Applicant:	HOM Furniture (Owner and User) Budget Truck Rental, LLC (Owner)
Locations:	7800 and 7850 Dupont Avenue South and 1217 Clover Drive
Request:	1) Rezoning 1217 Clover Drive from I-3 to C-3(PD) 2) Type II Preliminary and Final Plat to combine three lots into one lot 3) Preliminary and Final Development Plans for the renovation and expansion of an existing furniture store
Existing Land Use and Zoning:	Furniture store and truck rental facility; zoned C-3(PD) Freeway Commercial Center (Planned Development) and I-3 General Industrial
Surrounding Land Use and Zoning:	North – Interstate Highway 494 South – Place of assembly; zoned I-3 East – Motor vehicle sales (Class I); zoned I-3 West – Motor vehicle sales (Class I) and Interstate Highway 35W; zoned CR-1(PD)
Comprehensive Plan Designation:	Regional Commercial

PROPOSAL

Project Description: Rezoning from I-3 to C-3(PD) for 1217 Clover Drive, Type II Preliminary and Final Plat, Preliminary and Final Development Plans for the renovation and expansion of a furniture store.

Figure 1 – Rezoning 1217 Clover Drive form I-3 to C-3(PD)

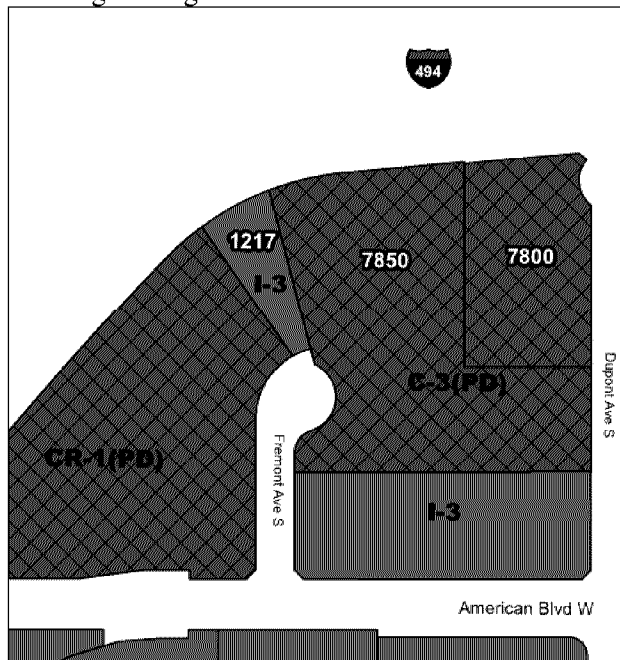
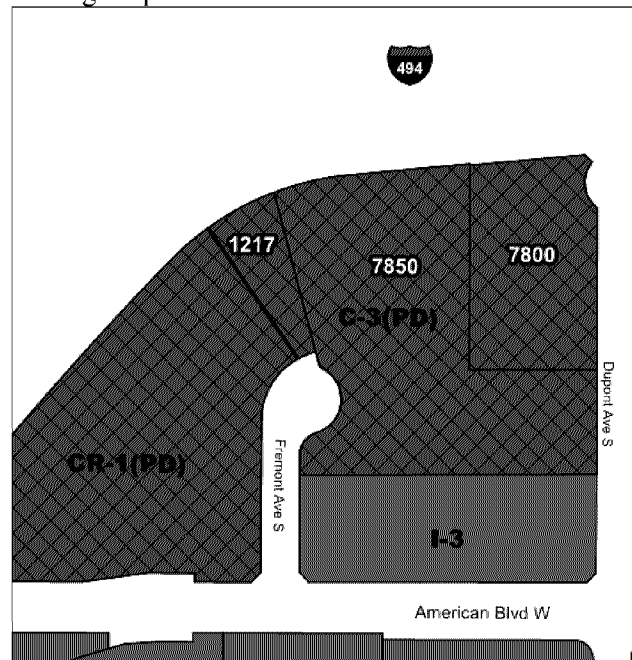
The existing zoning of 1217 Clover Drive, I-3 General Industrial, is not consistent with the Regional Commercial guidance. Retail sales and services is not a permitted use in the I-3 zoning district. Rezoning 1217 Clover Drive from I-3 to C-3 brings the site into harmony with the City's Comprehensive Plan. The addition of the Planned Development (PD) Overlay District relates to the Preliminary and Final Development Plans submitted by the applicant. If the subject Final Development Plans are approved, the PD Overlay must be extended over 1217 Clover Drive.

transit. In addition, the Plan seeks to enhance land use compatibility when considering requests to change zoning. The rezoning of 1217 Clover Drive to C-3(PD) is consistent with the aforementioned goals and strategies of the Comprehensive Plan. Staff recommends approval of the request to rezone the property from I-3 to C-3(PD).

Figure 2 – Front Setback Southwest Corner

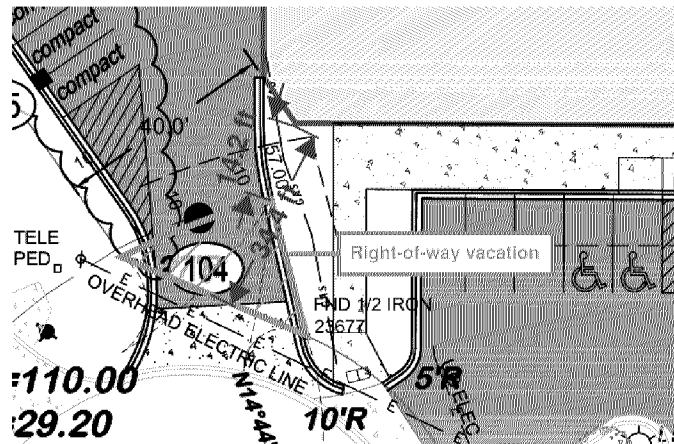
Extending the western portion of the building southward would result in a 14.2-foot setback from the property line along Fremont Avenue. City Code requires a 35-foot front setback in the C-5 zoning district. The applicants are requesting a deviation through the PD Overlay District for a reduced front setback. The reduced setback can be reviewed in Figure 2. Staff is supportive of the reduced front setback to Fremont Circle for two reasons:

- 2) **Potential 494-35W Interchange Impacts** – Shifting the western portion of the building slightly southward is beneficial in that it would move the structure further away from public right-of-way that may be needed to construct future interchange ramps. In staff's judgment, this circumstance warrants consideration of a reduced setback through PD flexibility.

Staff is supportive of a deviation to reduce the front setback to Fremont Avenue South from 35 to 14.2 feet from the existing property line. As noted above and shown in Figure 2, once the right-of-way vacation occurs, the setback will likely increase to approximately 34 feet, representing a condition that would be nearly compliant.
